BCA REPORT

Lot 201 Goonoo Goonoo Rd, Tamworth
(Tenancy 1 & 2)

Report No. BCA-25003-1 dated 05.02.2025

Figure 1 – Fire Wall Locations

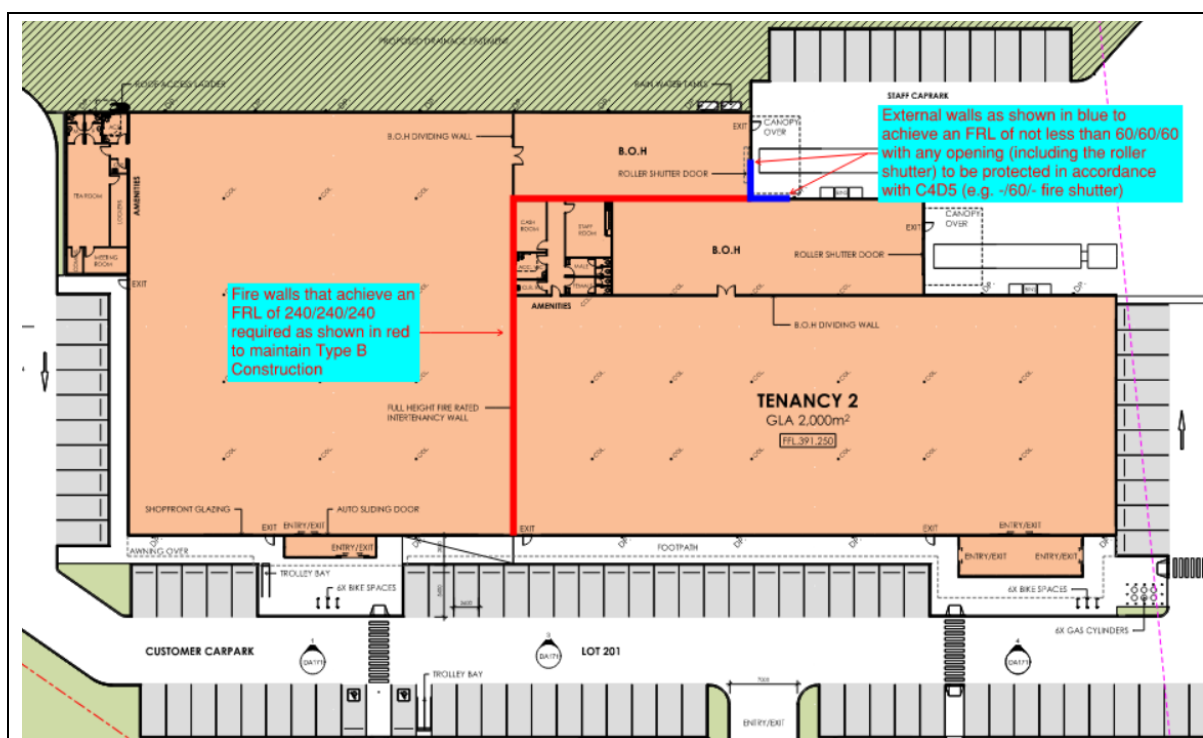
Part C3 – Compartmentation and Separation		
C3D3 General floor area and volume limitations	<p>The size of any fire compartment or atrium in a Class 5, 6, 7, 8 or 9 building must not exceed the relevant maximum floor area nor the relevant maximum volume set out in Table C3D3 and C3D6 except as permitted in C3D4.</p>	<p>Further Information / Clarification Required at CC Application Stage</p> <p>Subject to the provision of fire walls between Tenancy 1 & 2 as identified under Clause C3D8 below, the Retail Building complies with the maximum fire compartment size for Class 6 & 7b buildings of Type B Construction. Furthermore, the exact floor area and volume of each Fire Compartment is required to be confirmed by the Architect at CC Application Stage.</p>
C3D8 Separation by fire walls	<ul style="list-style-type: none"> • A fire wall must be constructed in accordance with the following: <ul style="list-style-type: none"> (a) The fire wall has the relevant FRL prescribed by Specification 5 for each of the adjoining parts, and if these are different, the greater FRL. (b) Any openings in a fire wall must not reduce the FRL required by Specification 5 for the fire wall, except where permitted by the Deemed-to-Satisfy Provisions of Part C4. (c) Building elements, other than roof battens with dimensions of 75 mm x 50 mm or less or sarking-type material, must not pass through or cross the fire wall unless the required fire-resisting performance of the fire wall is maintained. • Separation of fire compartments — A part of a building separated from the remainder of the building by a fire wall may be treated as a separate fire compartment if it is constructed in accordance with (a) and the fire wall extends to the underside of: <ul style="list-style-type: none"> (a) a floor having an FRL required for a fire wall; or (b) the roof covering. 	<p>Further Information / Clarification Required at CC Application Stage</p> <p>Fire walls that achieve an FRL of 240/240/240 are required to be provided between Tenancy 1 & 2 as identified under Figure 1 below. Details and design certification from the Architect & Structural Engineer to be submitted with the CC application demonstrating compliance.</p>
